# Advanced Water Recycling Centre and Pipelines

Flood Emergency Response  
CEMP Sub-plan

Document No: USCP-JHG-MPL-ENV-0004  
Revision: B

**Subject: Environmental Representative (ER) review and approval – Revised Flood Emergency Response CEMP Sub-plan, Revision B**

Figure 7-1 Location of compounds (Source: USC AWRC response to request for information 44447594 – flooding, 11 July 2022).

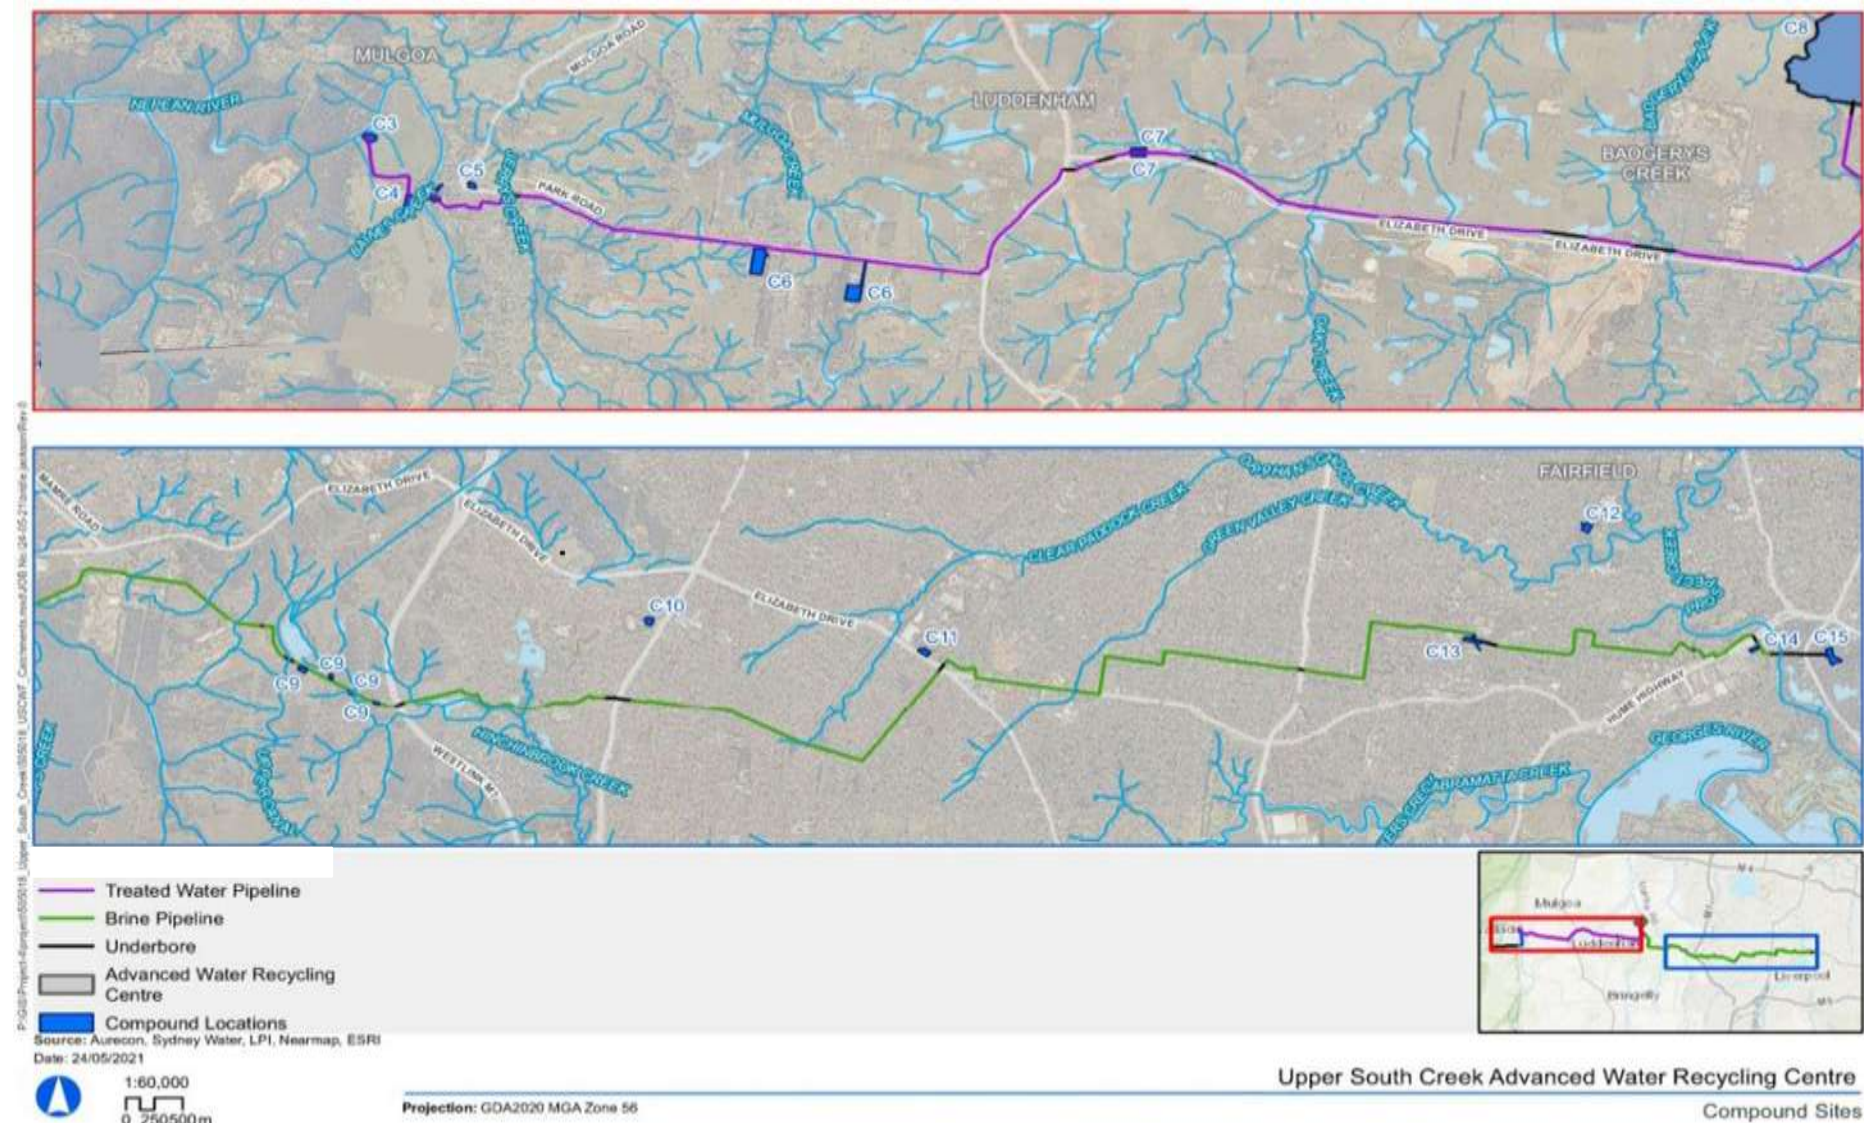
Comment Raised	Date Raised	How Addressed / Justification Why Not Addressed
		The remaining management measures identified in Table 8-1 have been reviewed and are applicable. Management measures have been informed by the updated modelling assessments (i.e. flood extents), updated management measures (UMM) within Appendix B of the Submissions Report, Minister's Conditions of Approval (MCOA) and best practice.
Section 7.2 describes the potential impact on the construction compounds and its significance. The section should provide maps for the location of these compounds (C1 - C15) and the location of Nepean River instream construction works. Without this information it is not possible to review this section.	29/03/2023	Figure 7-1 has been included to show the indicative location of these compounds and water crossings
